MFN 06-218

Docket No. 52-010

**Subject: Response to Portion of NRC Request for Additional Information
Letter No. 35 Related to ESBWR Design Certification Application –
Solid Waste Management System – RAI Numbers 11.4-1 through
11.4-11**

Solid Waste Management System

Figure 11.4-1. Solid Waste Management System Process Diagram

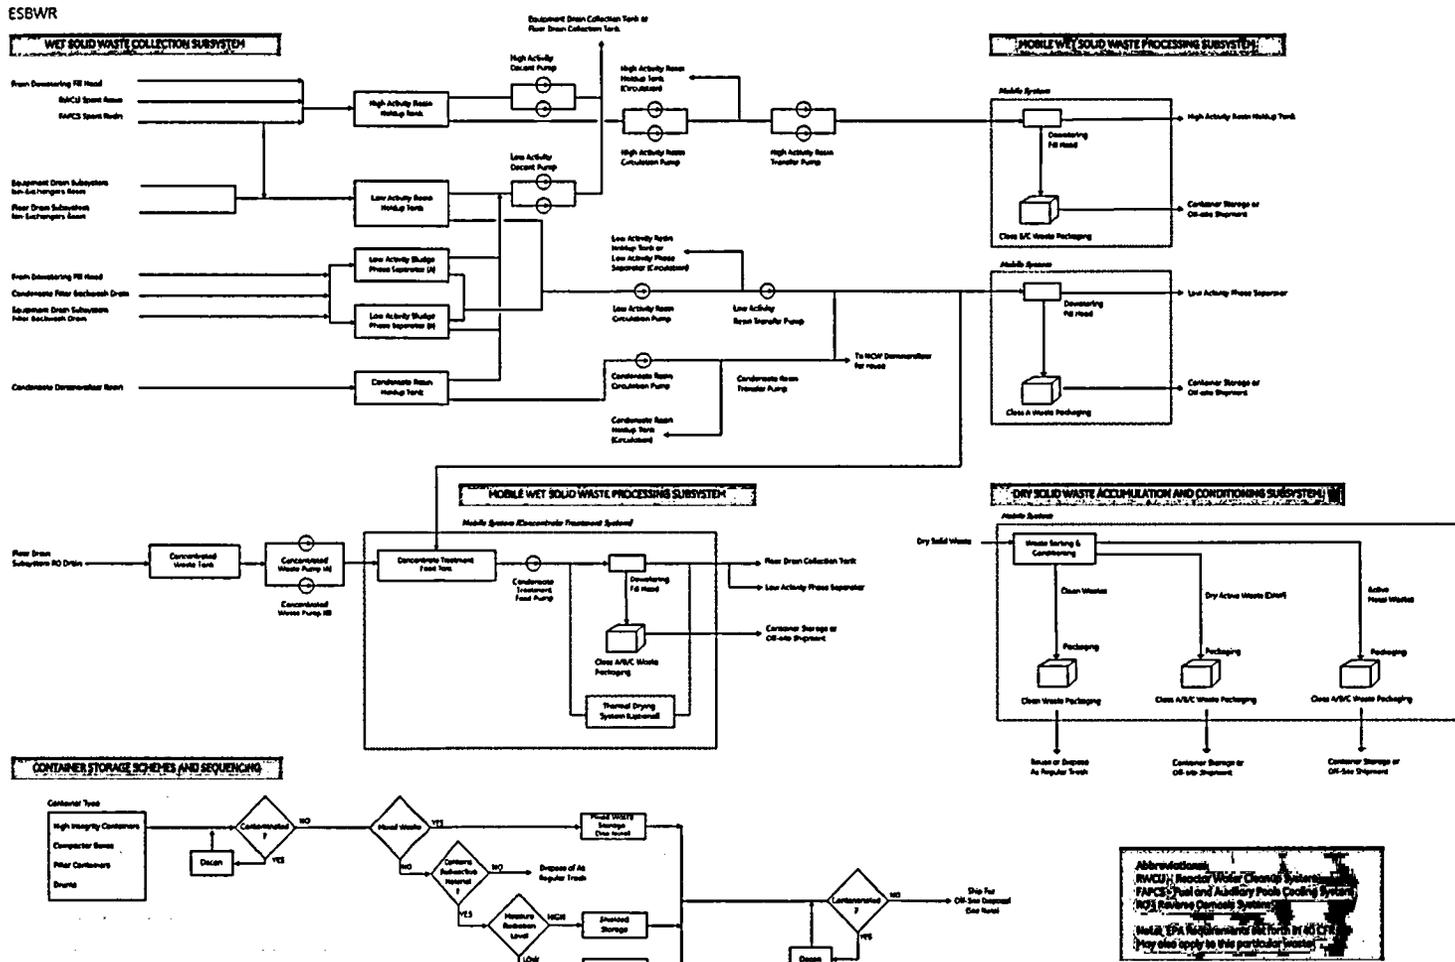
DCD Tier 2, Section 11.4 states that the four subsystems of the solid waste management system (SWMS) are depicted on Fig. 11.4-1. A review of Figure 11.4-1 indicates that the container storage subsystem is not shown in this figure. Update DCD text and figure accordingly.

Figure 11.4-1 and Section 11.4 have been revised to include the container storage subsystem. Attached to this RAI is Draft DCD Section 11.4, Rev. 02, including Figure 11.4-1, Rev. 02, for your review and use.
